**TSG-RAN Meeting #8
Düsseldorf, Germany, 21 – 23 June 2000**

RP-000212

Title: Agreed CRs to TS 25.142

Source: TSG-RAN WG4

CHANGE REQUEST

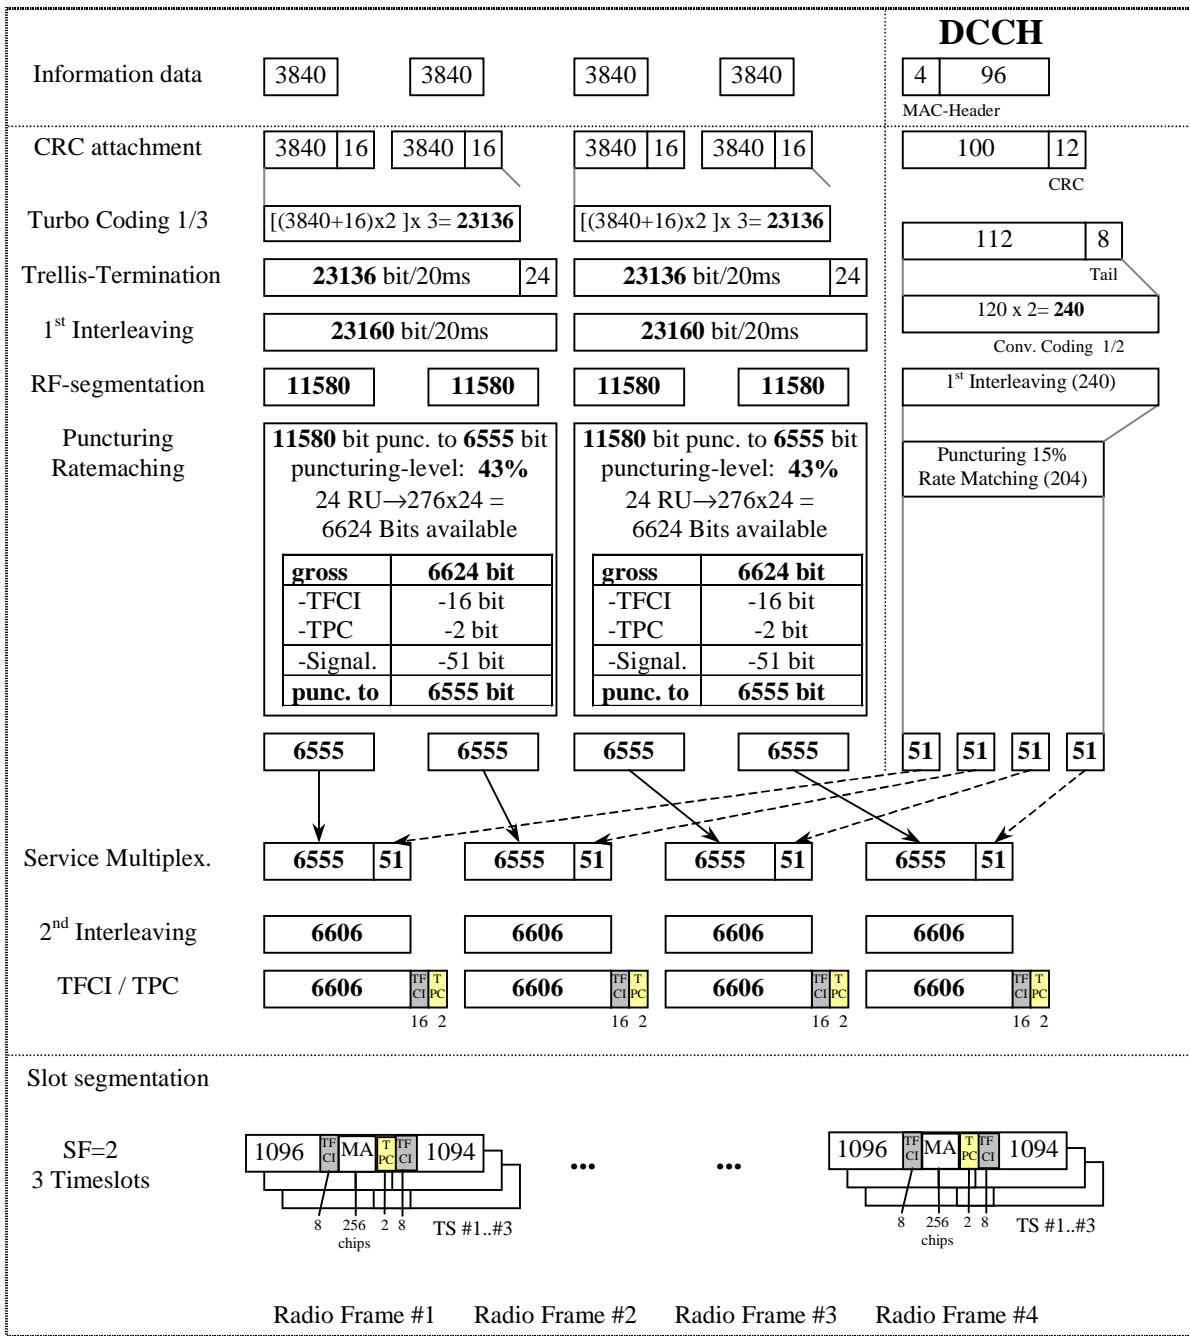
Alignment of the UL reference measurement channels with current RAN WG1 and WG2 specifications

Parameter	
Information data rate	12.2 kbps
RU's allocated	2 RU
Midamble	512 chips
Interleaving	20 ms
Power control	2 Bit/user
TFCI	16 Bit/user
Inband signalling DCCH	2 kbps
Puncturing level at Code rate 1/3 : DCH / DCCH	5% / 0%

Parameter	
Information data rate	64 kbps
RU's allocated	1 SF4 + 1 SF16 = 5RU
Midamble	512 chips
Interleaving	20 ms
Power control	2 Bit/user
TFCI	16 Bit/user
Inband signalling DCCH	2 kbps
Puncturing level at Code rate : 1/3 DCH / 1/2 DCCH	41.2% / 10%

Parameter	
Information data rate	144 kbps
RU's allocated	1 SF2 + 1 SF16 = 9RU
Midamble	256 chips
Interleaving	20 ms
Power control	2 Bit/user
TFCI	16 Bit/user
Inband signalling DCCH	2 kbps
Puncturing level at Code rate : 1/3 DCH / 1/2 DCCH	44.4% / 16.6%

Parameter	
Information data rate	384 kbps
RU's allocated	$8 \cdot 3TS = 24RU$
Midamble	256 chips
Interleaving	20 ms
Power control	2 Bit/user
TFCI	16 Bit/user
Inband signalling DCCH	2 kbps
Puncturing level at Code rate : 1/3 DCH / 1/2 DCCH	43.4% / 15.3%

Figure 6.6.2.1.2.1: Spectrum emission mask

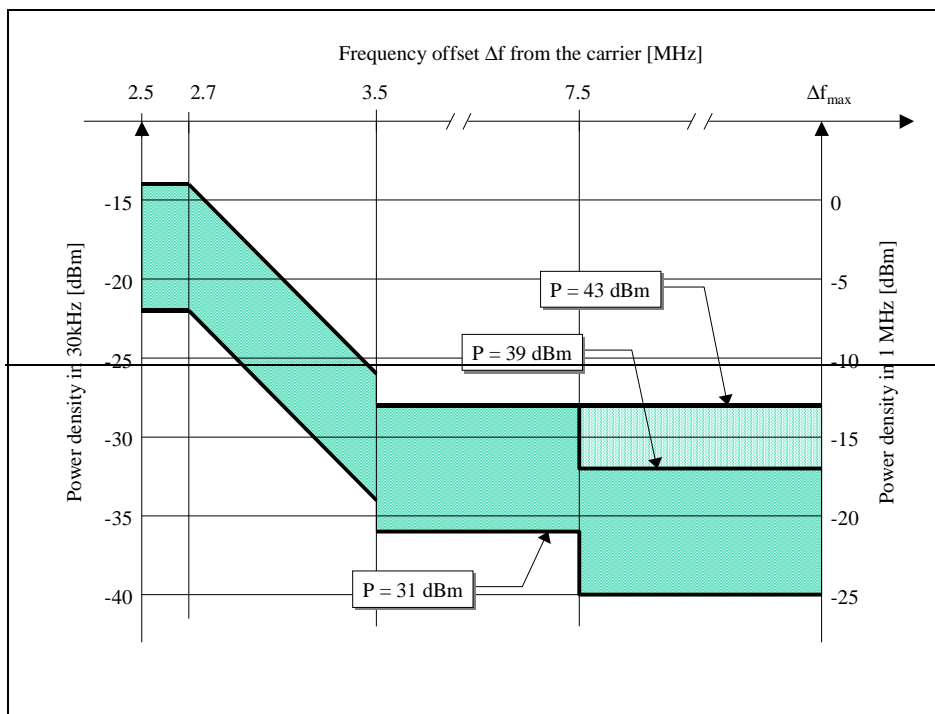
Alignment of the conformance test description for spectrum emission mask with recent amendments incorporated into the core specification TS 25.105 via CR 030. The first columns in tables 6.6.2.1.2.1 - 4 are removed, as these are no longer relevant to conformance testing. The diagram is removed since it relates to the first column; however, it may be considered useful to add a new diagram to provide clarification.

For regions where this subclause applies, the BS spectrum emissions shall be within the mask defined in tables 6.6.2.1.2.1 to 6.6.2.1.2.4. A graphical representation of these tables is given in figure 6.6.2.1.2.1. This mask requirement shall be met by a base station transmitting on a single RF carrier configured in accordance with the manufacturer's specification. Emissions shall not exceed the maximum level specified by the mask in tables 6.6.2.1.2.1 to 6.6.2.1.2.4 in the frequency range with of f_{offset} Δf from 2,5 MHz to $\Delta f_{offset_{max}}$ from the carrier frequency, where:
